REGULAR MEETING – PLANNING AND ZONING COMMISSION AGENDA

**NOVEMBER 5, 2025, 6:00 PM
BY ZOOM VIRTUAL MEETING**

- I. **CALL TO ORDER**
- II. **ROLL CALL & SEATING OF ALTERNATES**
- III. **PUBLIC HEARINGS**
 - A. **#2025-56 SP/CAM – Alpha5MK 19 Day , LLC – 19 Day Street (District 2, Block 58, Lot 44) – Special permit for a proposed multifamily building with 32 units — Public hearing, report & recommended action**
 - B. **#2025-59 R – RMS Real Estate Group, LLC – Zoning Regulation Text Amendment to Article 7 (Sign Standards) to create a “Cornice Sign” sign type and permit Cornice Signs within the CD-3C and CD-4 zones - Public hearing, report & recommended action**
- IV. **REVIEW AND ACTION ON APPLICATIONS**

ALPHA5MK 19 DAY, LLC
19 DAY STREET, NORWALK, CT
APPLICATION FOR SPECIAL PERMIT FOR PARKING
Per Sec. 4.12.6 – Norwalk Zoning Regulations
NARRATIVE – SCHEDULE A
Revised 9-11-25

Figure 7: Façade Composition on North Elevation

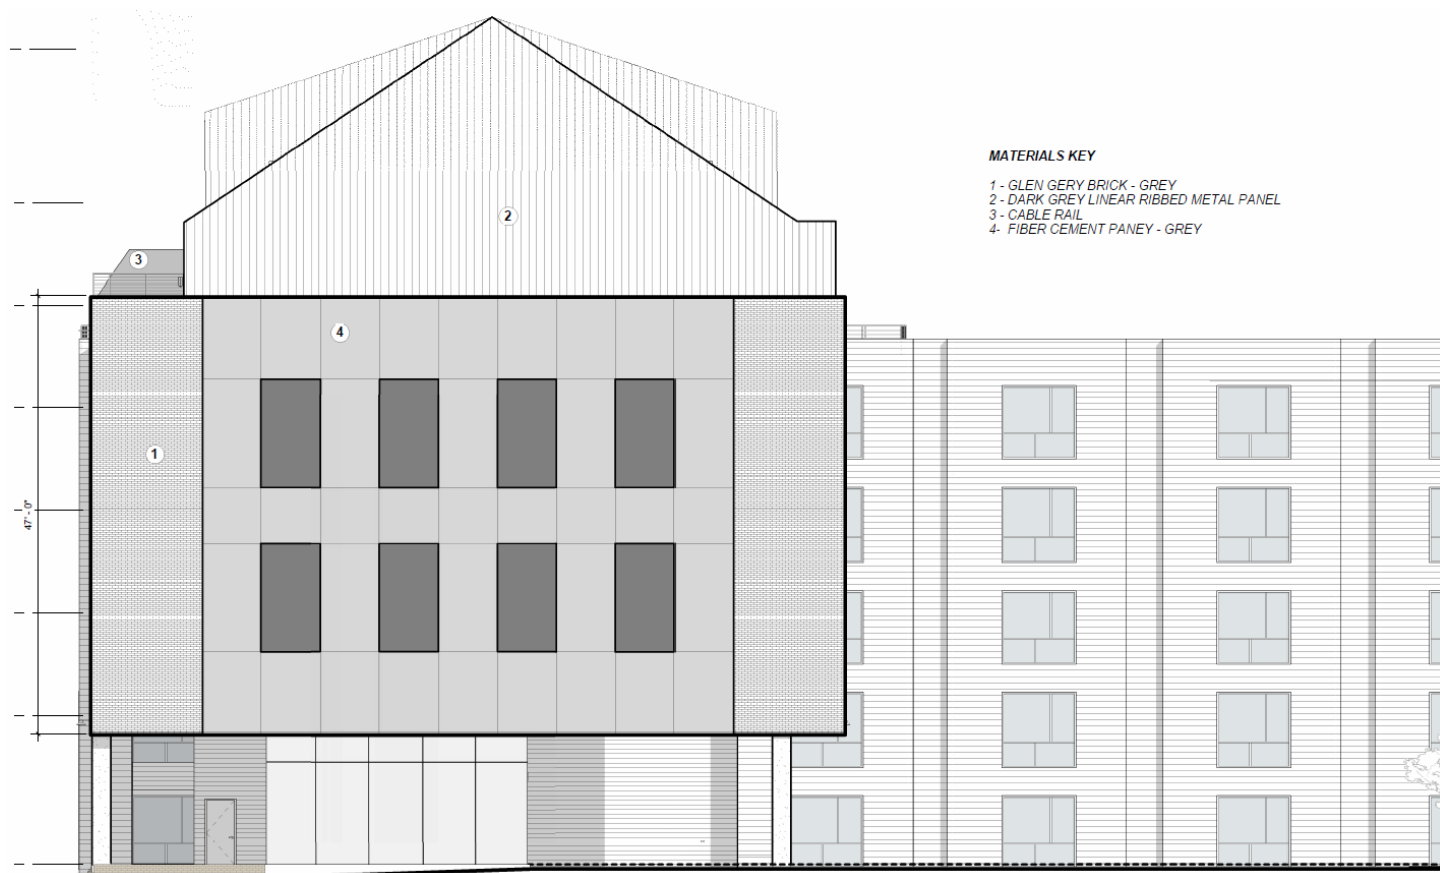
We appreciate that the Applicant provided more clarity on the façade composition shown in the North Elevation. However, the material of the eight dark panels is not labeled. There should be a fifth material listed which describes these panels. Additionally, the Applicant should label the material on the ground floor level trash room as fiber cement panel.

Figure 3: Vehicular Entrance and Exit to Site

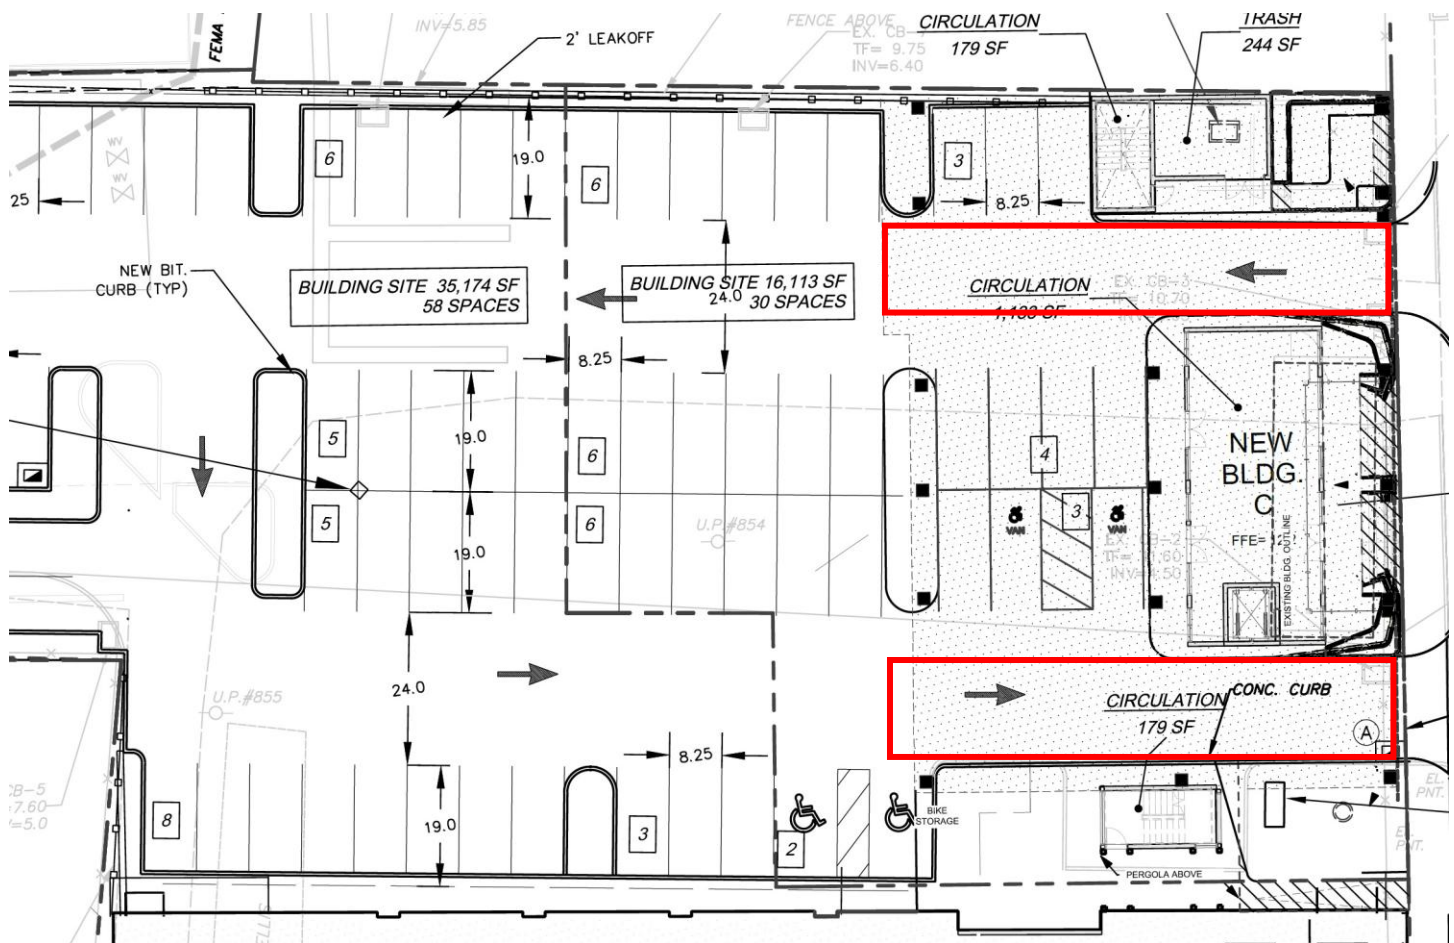
The Applicant should provide dimensions for the vehicular entrance and exit, highlighted in red in Figure 3.

Ingress and egress drives have been dimensioned at 16'. A full internal circulation look has been provided. The 24' drive aisle will allow vehicles to pass while trash is being serviced. Property management to coordinate pickup locations with service providers and have all activities occur on site.

Figure 4: Screening from Parking Area

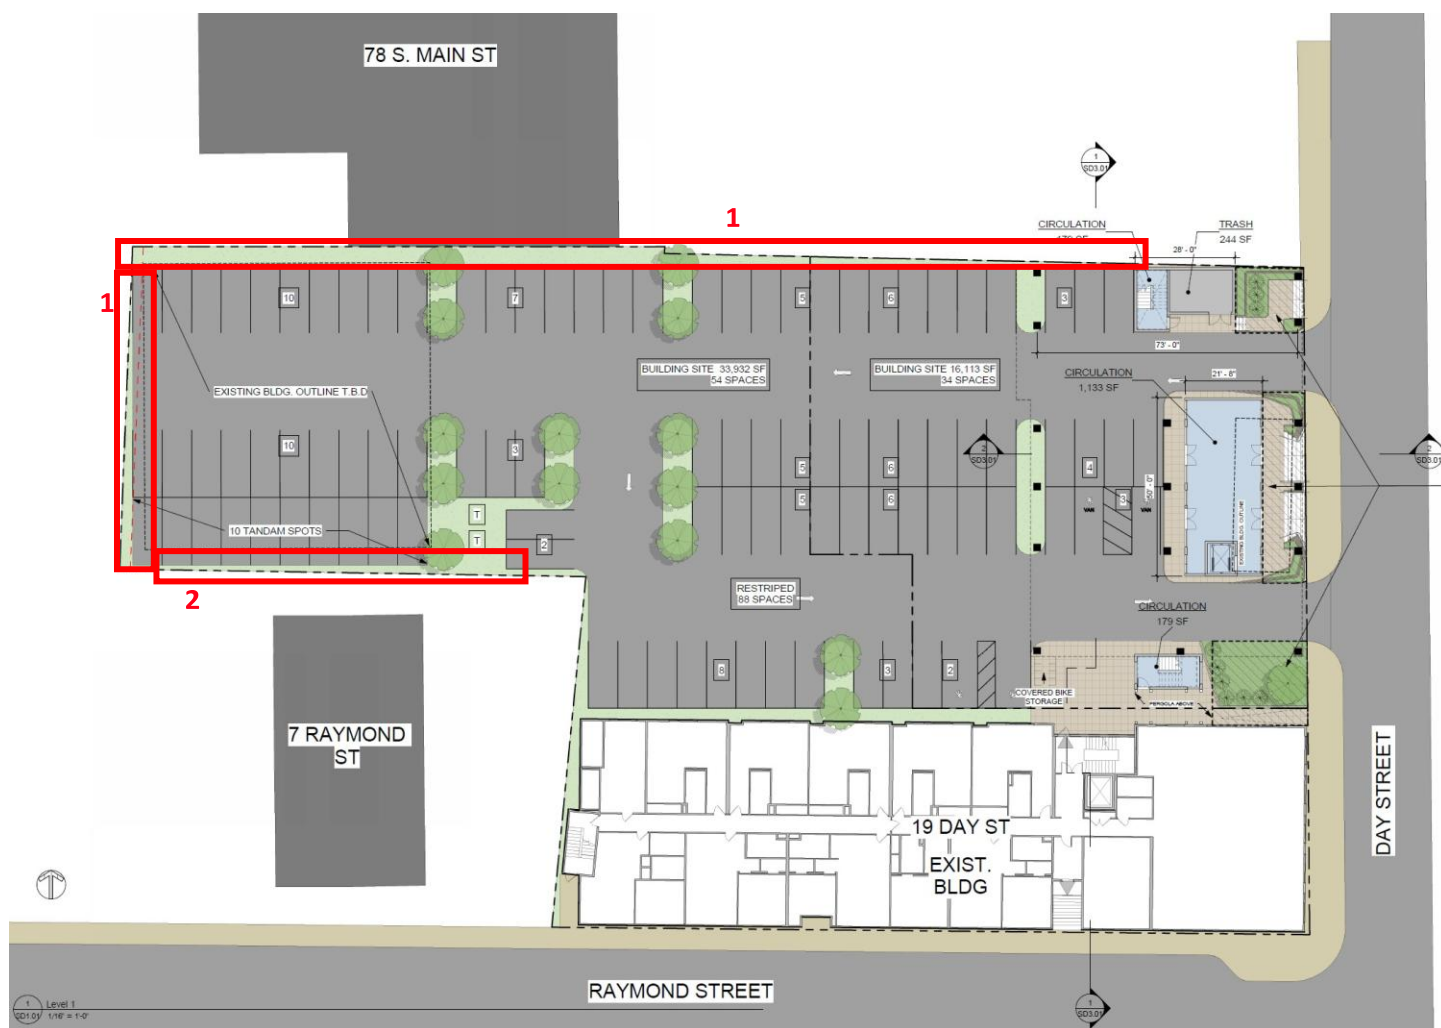
Landscape buffers and/or fencing should be added to the north and west of the property to create screening between adjacent sites, shown in Figure 4 as Item 1. The recommended screening on the west of the site would result in the removal of three parking spaces, however, the proposal already exceeds the required parking minimum.

The previously submitted plan showed 6 trees on the south side of the parking lot adjacent to 7 Raymond St, shown as Item 2 in Figure 4. We would like to clarify if these have been removed. If they have been removed, there should be some sort of landscaping or fencing to screen the parking area from the adjacent property.

Spaces must remain at 88 per zoning regulations. A fence system is shown within the buffer provided in the civil drawings. Trees shown on civil/landscape plan.

Figure 5: Parking Area

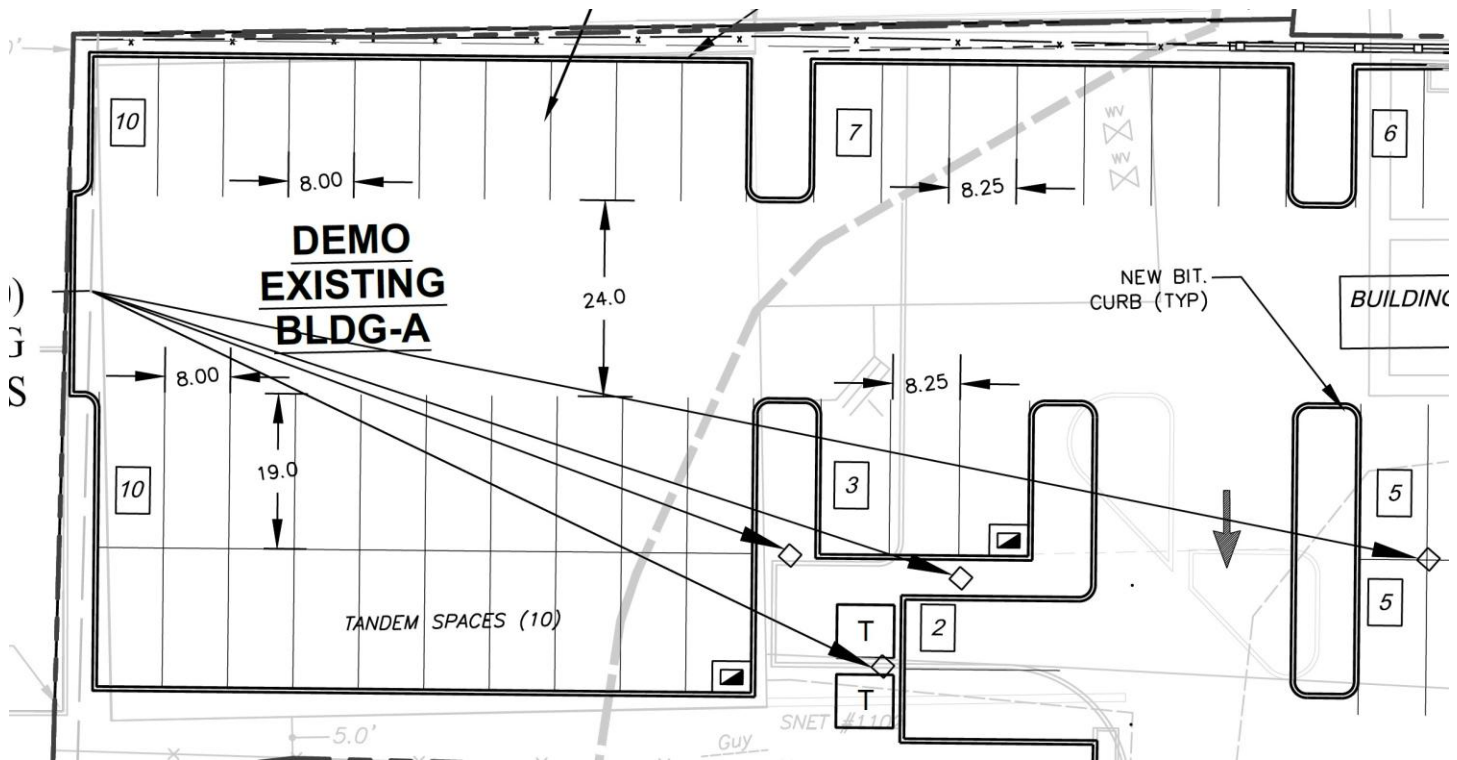
While we defer to TMP on this issue, the parking spaces do not appear wide enough. Each space should be a minimum of 8.5 feet wide. They are currently shown as 8.25 and 8 feet (Figure 5).

The current zoning regs specify parking space width as a range of 8-9ft and a stall depth of 19' (See section 4.3.12.B-4). Spaces to be adjusted to meet current regulations as required.

Figure 6: Terrace

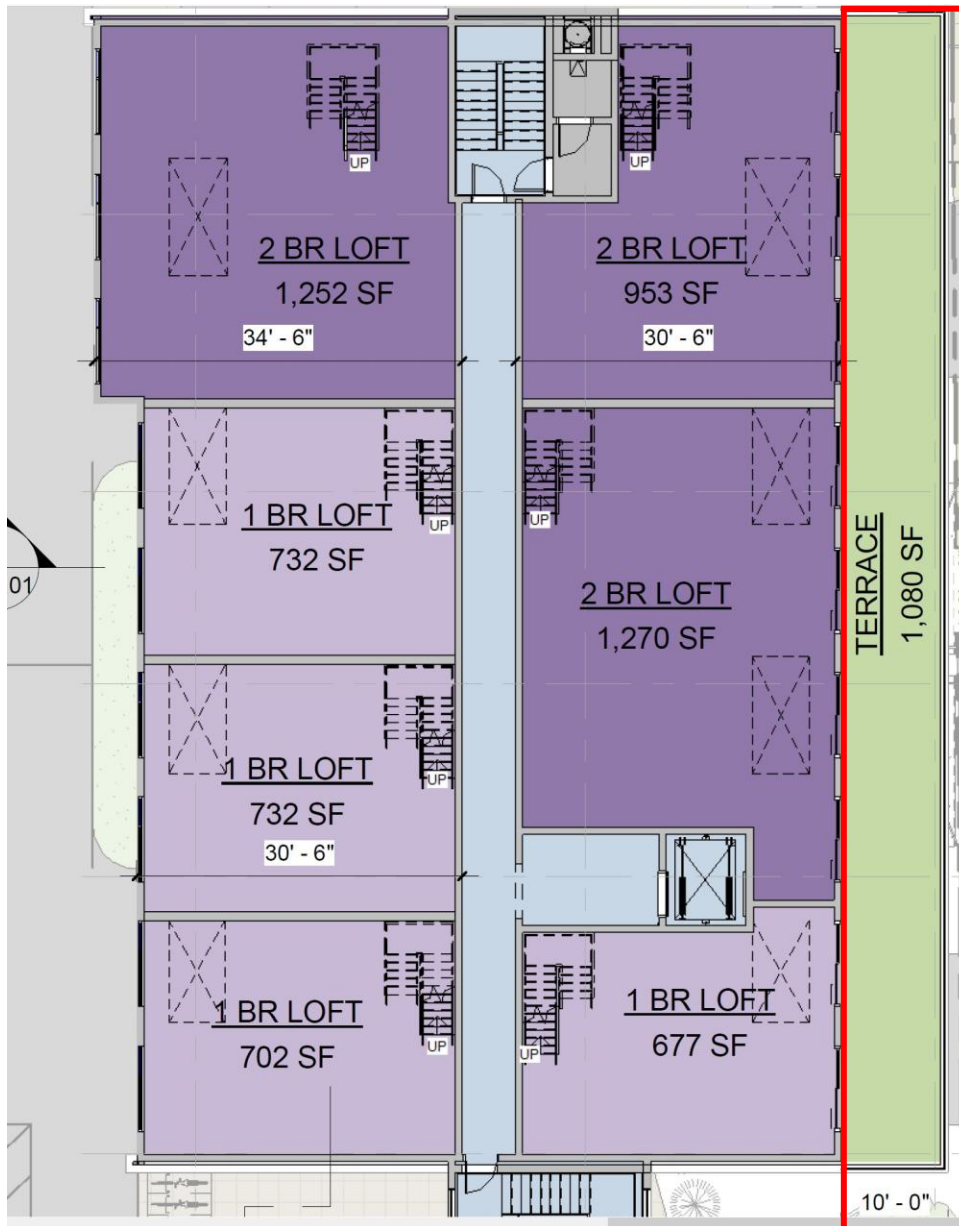
The Applicant should clarify terrace access (Figure 6). The floor plans do not show doors to access the terrace. Additionally, the Applicant should clarify whether there will be unit dividers on the terrace. It could present a privacy issue if people can approach unit windows facing the terrace. The dividers are also important to clarify, as they will be visible from the street. Lastly, the Applicant should specify whether there will be a lighting system on the terrace and what that would look like.

Terrace dividers are shown. Access to terrace is via glass sliders. Lighting is shown as per SD1.05

Figure 7: North Elevation

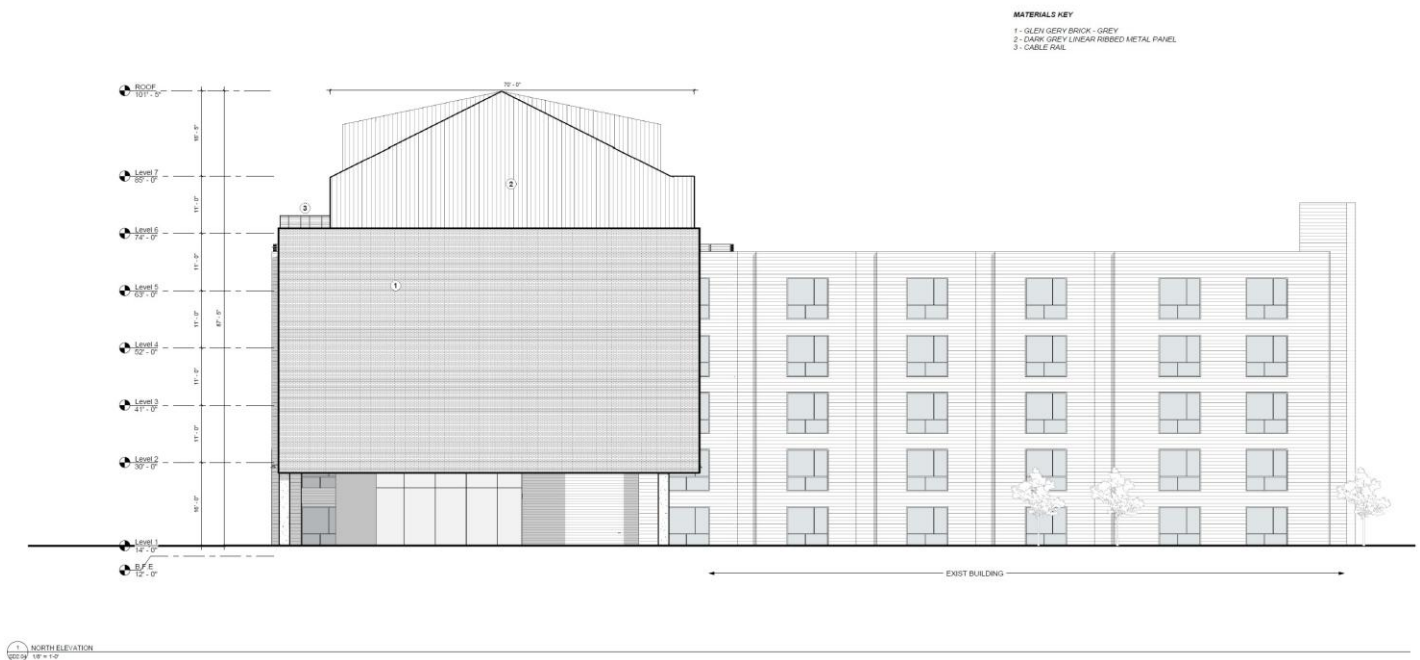
The North Elevation (Figure 7) shows a large blank façade. The Applicant should include vertical or horizontal components to break up the large expanse of blank wall.

Option A is to commission art on this façade. Option B is to create material patterning using panels. See drawings sheet SD2.04
